REMARKS

Claims 1- 8, 10 - 18 and 20 are in this Application and are presented for reconsideration. By this Amendment, Applicant has amended claims 1 and 11 to highlight the important combination of features which define over the prior art of record.

Prior Art

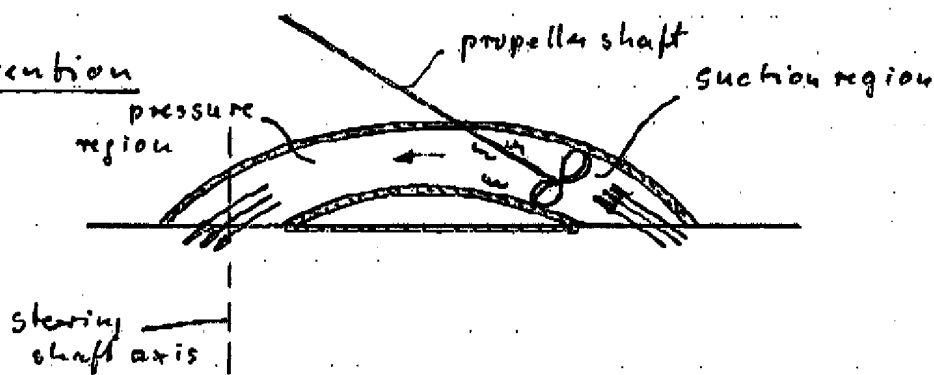
Because of the same water flow in which the propeller is situated is also distributed by the propeller shaft a turbulent flow region is formed upstream of the propeller (see attached sketch). This region of turbulence increases the danger of cavitation at the propeller and decreases the power of the hydrojet. Furthermore, this has been found to increase the level and degree of vibrations of the hydrojet and therefore also of the watercraft.

Contrary to this known arrangement, the present invention as claimed, provides an arrangement, in which the propeller shaft must be in the pressure region of the pump housing (on a delivery side of the pump housing section; compare sketch 2 of the figure below). In this arrangement, the water flow arrives at the propeller undisturbed. This provides a situation where even laminar flow feeds into the propeller region. This ensures an optimal incoming flow at the propeller. The power of the hydrojet increases and the danger of cavitation is much lower.

The steering shaft of the deflecting grid is on opposite sides in the examples shown in sketch 1 and 2.
